IN THE UNITED STATES PATENT AND TRADEMARK OFFICE

In re Application of: HAMMER, Mordechai

Serial No. : 08/894,211

For : EXTENSIBLE AND RETRACTABLE
ELEMENTS AND VARIOUS USES FOR THE
ELEMENTSGroup Art Unit 3626
Examiner: A. KnightRaanana, Israel
February 13, 2002**RECEIVED**

FIG. 1

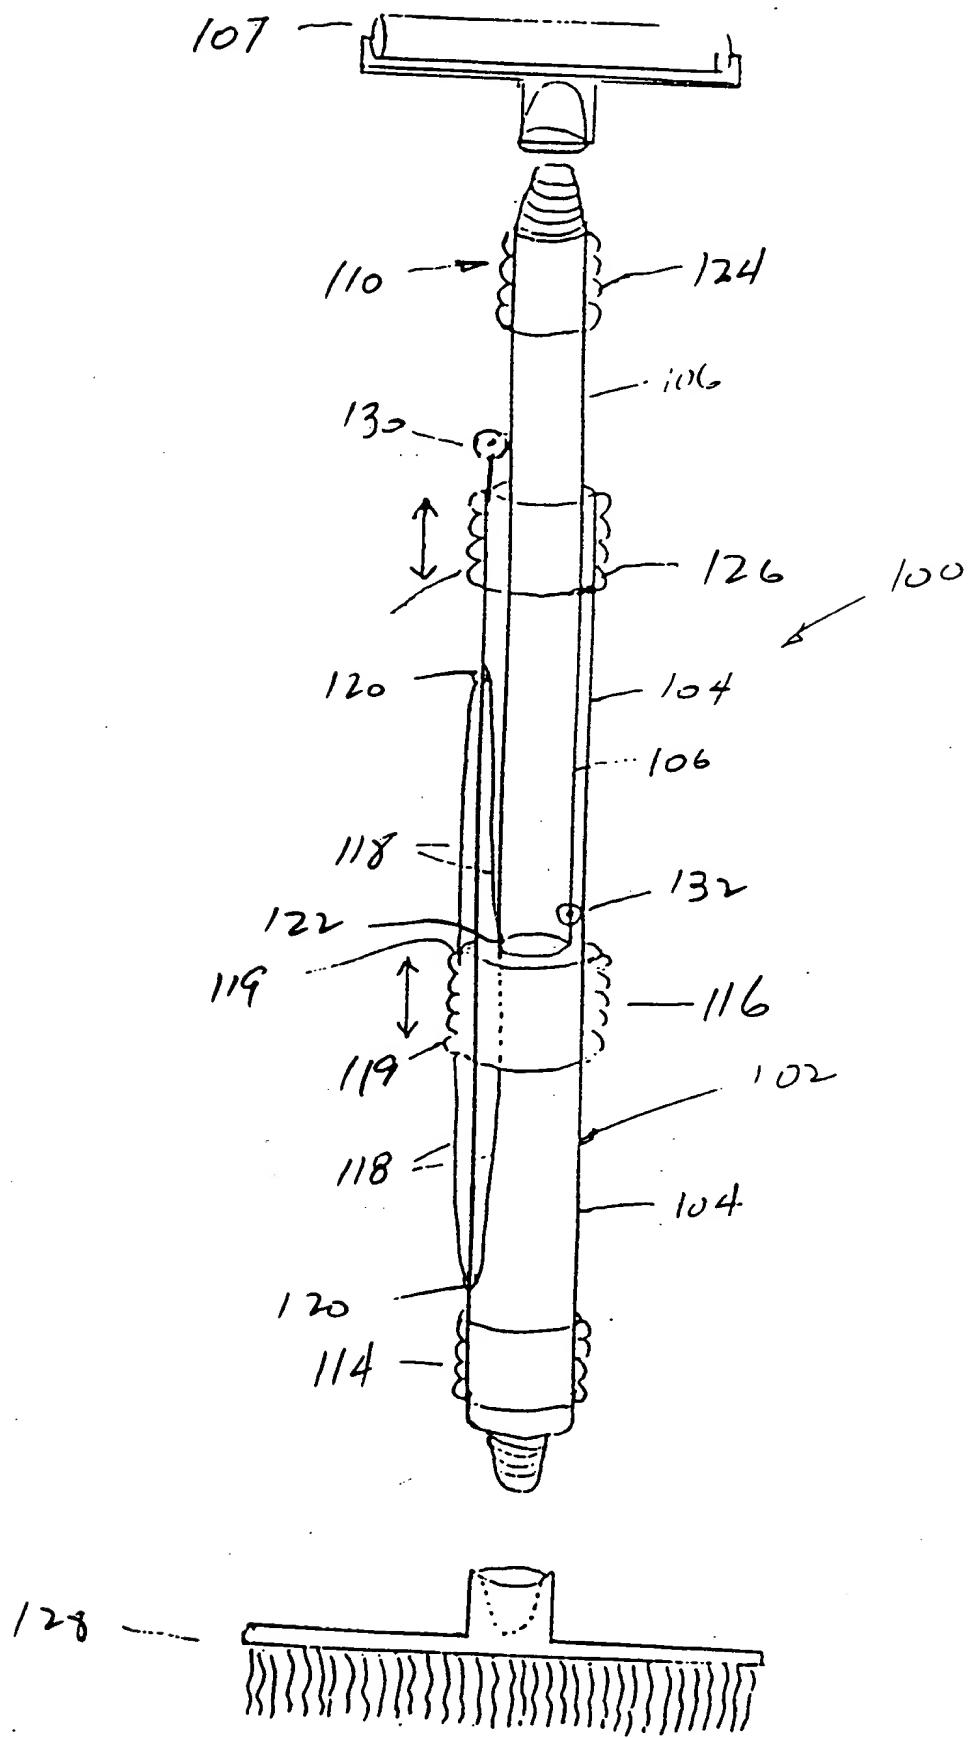
at least first and second hand-movable elements [104, 106] each having anterior and posterior ends, said elements extending in the same orientation, each element having at least one point thereon connectable to a tool [107 - note: 107 in Fig. 1 drawing is an error to be corrected to be 101 per text] or other object; and
